SERVICE BULLETIN

N° 139-696

DATE: December 9, 2021

ATA 63 – MAIN GEAR BOX REMARKING

Figure 1

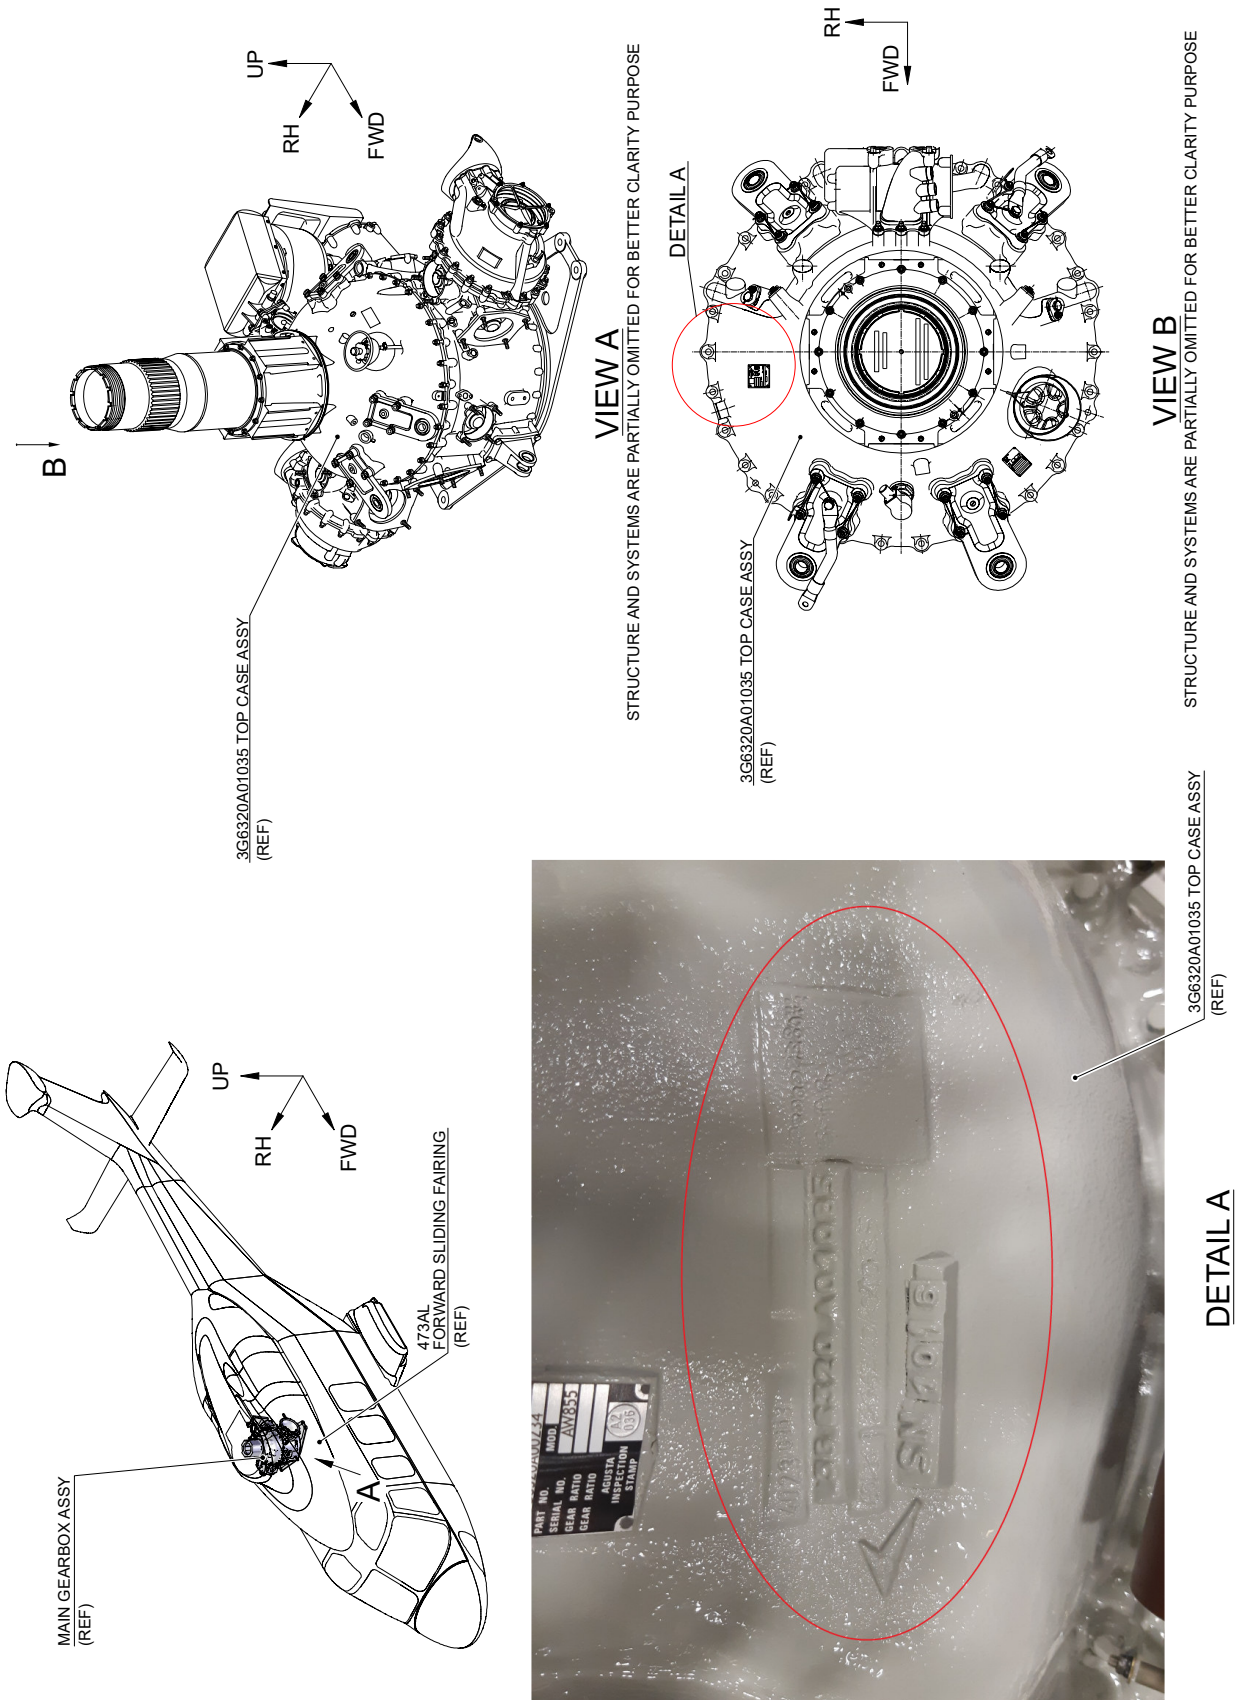
5. With reference to Figure 1, gain access to the top case assy P/N 3G6320A01035 of the MGB P/N 3G6320A00134 and check the S/N marked on the top case assy surface.
6. With reference to Figure 2, search in the table the S/N read on the top case assy surface.
7. If the S/N read on the top case assy is found in the table of Figure 2, mark "A1" after the MGB S/N on the MGB identification plate by means of permanent black ink felt pen with Acrylic Lacquer (C081) or by means of vibropen, mark "A1" after the MGB S/N on the MGB log card and go to step 9.
8. If no correspondence is found between S/Ns on Figure 2 and the top case assy S/N, proceed with the following step.
